802.3dj D3.0

Comment Resolution

Electrical Topics

Vf (Preset 1) –vs- Rpeak

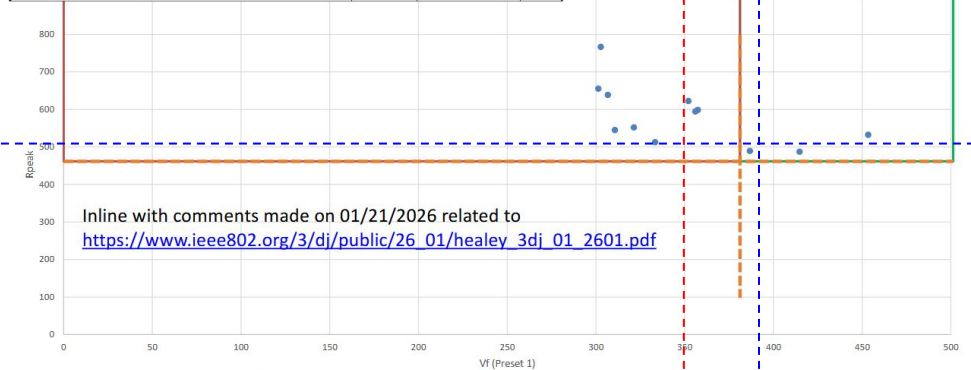
Vf minimum value of .389V still fails the majority of early designs.

The interop report out:
https://www.ieee802.org/3/dj/public/26_01/calvin_3dj_01a_2601.pdf Page 23 shows 9 out of 12 modules failing Vf. We either need to review the measurement methodology in Vf (which is not new) or consider further reduction of the Vf values to 350mV.

Blue overlay lines show (approximately) the new limit values proposed by comment #175.
 Red overlay line shows the new limit value proposed by comment #277.

PROPOSED REJECT.
 The v_f specification is an important component of the COM analysis that supports the loss budget of 32 dB for C2M applications. Reducing the minimum v_f would undermine this analysis and prevent interoperability with worst-case hosts.
 The information in the referenced presentation does not justify reducing the v_f limits. It shows that some of the tested modules met the requirements. Devices that failed the requirements might have not been configured correctly or might be non-compliant.
 [Editor's note: changed clause/subclause/page from 179D/179D.6.3/821 to 176D/176D.6.5/822]

Figure 179B-3—Mated test fixtures common-mode to differential-mode insertion loss requirements

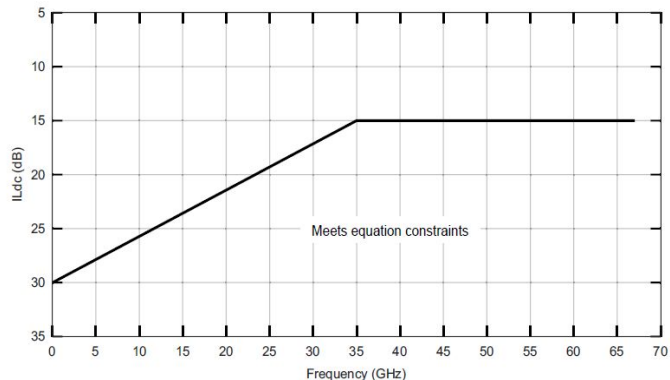
Intrapair skew has not been directly considered for the MTF. Although intrapair skew is included in the computed differential mode to differential mode insertion loss, the effect of skew has not been explicitly specified. Common mode to differential mode insertion loss does contain elements of skew. An either or specification for SCMR_CH should be added to control MTF intrapair skew.

The common-mode to differential-mode insertion loss of the mated test fixtures measured in both directions shall meet Equation (179B-6) as illustrated in Figure 179B-3. or the channel signal to common-mode ratio (SCMR_CH) shall exceed 12 dB using the procedure described in 179.11.7.

The comment suggests adding a minimum SCMR_CH of 12 dB as an alternative to the frequency mask of Equation 179B-6.

"The mated test fixture shall comply with at least one of the following conditions:

- The common-mode to differential-mode insertion loss of the mated test fixtures measured in both directions meets Equation (179B-6) as illustrated in Figure 179B-3.
- The channel signal to common-mode ratio (SCMR_CH) is greater than <x> dB using the procedure described in 179.11.7."
